<b>TO:</b> Ms. Ruth E. Grady, E.I. St. Johns River Water Management District Department of Water Resources 975 Keller Road Altamonte Springs, FL 32714-1618	<b>DATE:</b> May 3, 2007  <b>KCG JOB#:</b> 432.020  <b>RE:</b> 7-Eleven Hancock Rd. And SR 50 Application #42-069-67971-2 Associated Permit Number #42-069-67971-1
---	--

**Re: 7-Eleven at SR 50 and Hancock Road;  
Application Number 42-069-67971-2  
Associated Permit Number 42-069-67971-1**

In response to your comments requesting additional information on the 7-Eleven at SR 50 and Hancock Road, we are pleased to offer the following responses to your comments:

SHEET C-4B

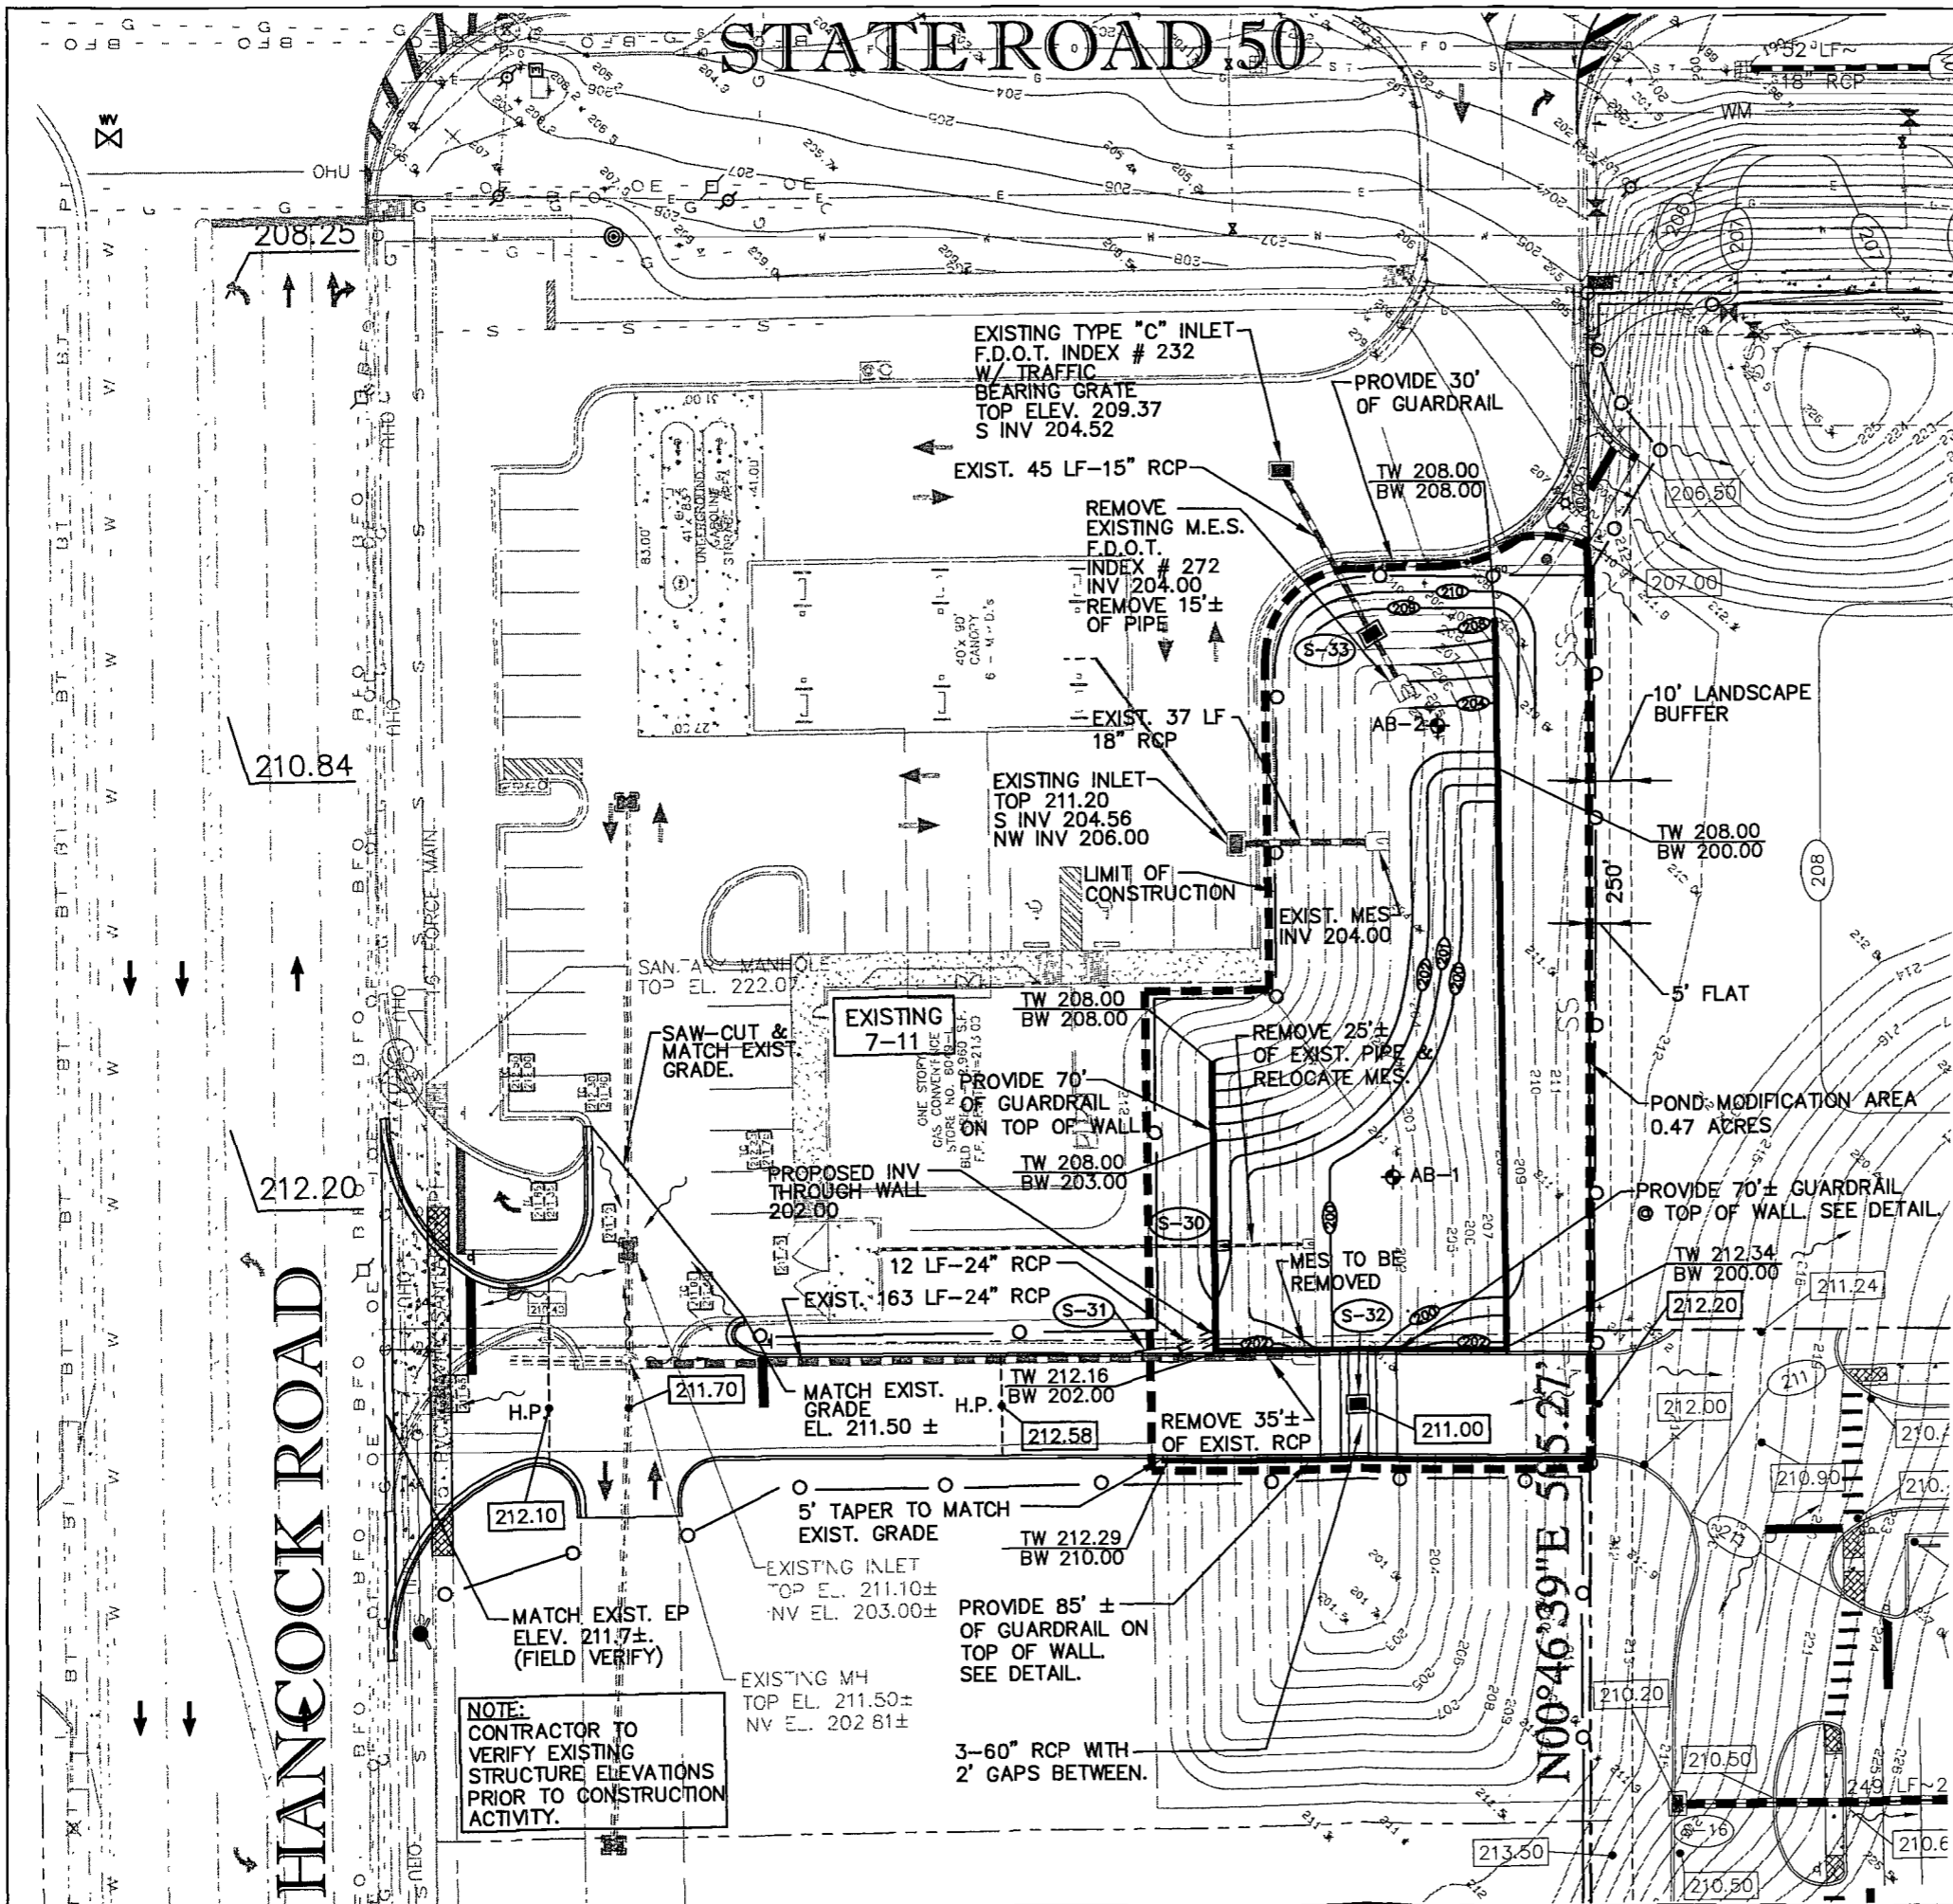
4. Please provide a revised *Sheet C-4* of the construction plans (3 copies) drawn with a clearer print quality and including the following information:

- Clearly delineate the limits of the proposed modifications.  
**The pond modification area is 0.47 acres.**
- Clearly show all pertinent information and invert elevations relating to the proposed modifications, including the area encompassing the pond outfall weir/structure.  
**Please see attached sheet C-4B.**
- Ensure consistency with the parameters utilized in the routing calculations.  
**Please see attached drainage calculations.**

- b. The pond bottom elevation (200.00 feet) utilized in the water quality and quantity analysis does not appear to be consistent with that (201.00 feet) indicated on the construction plans. Please clarify and revise where appropriate, for accuracy with the post development condition.

**Please see attached sheet C-4B which indicates the limits of the proposed modification.**

**The modified pond bottom will be at elevation 200. Please see attached sheet C-4B.**
